# DESIGN BY MIR

## STATEMENT OF ENVIRONMENTAL & EFFECT

ADDRESS – 152 RODD STREET, SEFTON  
PROPOSAL – PROPOSED SECTION 4.55 MODIFICATION

DP – 7439                      LOT 10

#### UNIT 1 & 2 GROUND LEVEL

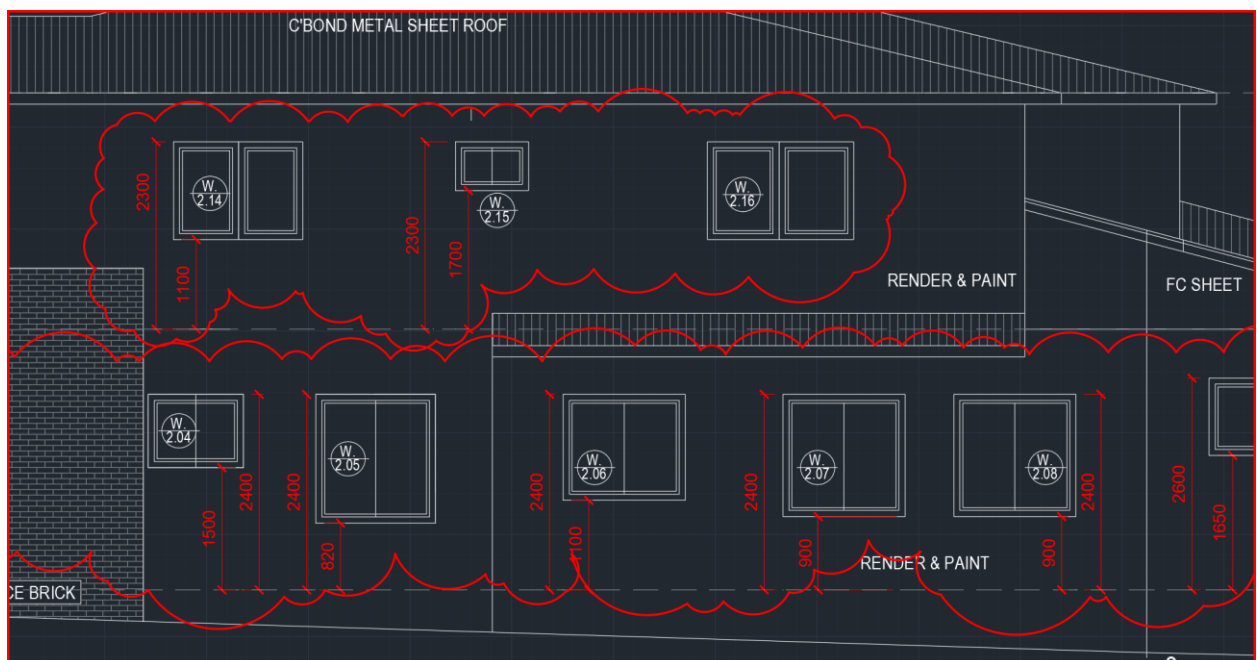
On Unit 1 & 2 the DA stamped plans illustrated the two windows (W1.02 & 1.03 for Unit 1 and W2.02 & 2.03) in both garages but in section 4.55 application we proposed to keep only one window with different size and head height. Window (W1.03 for Unit 1 is deleted and Unit W2.03 is deleted as well. The proposed new sizes of the windows on both garages are the identical (2.44 width & 0.95 Height) but the height is 2.6m high which is different from DA stamped plans.

The ground Windows (W1.04,5,6, 7 & 8 for Unit 1 and W2.04,5,6,7,8 and 9 for Unit 2), the size of these window which are mentioned are modified and their head heights are different from stamped plan. Their heights are raised by head height 300mm so the proposed head height will be 2.4 from 2.1m.

Also the following windows illustrated below, the height are raised and the
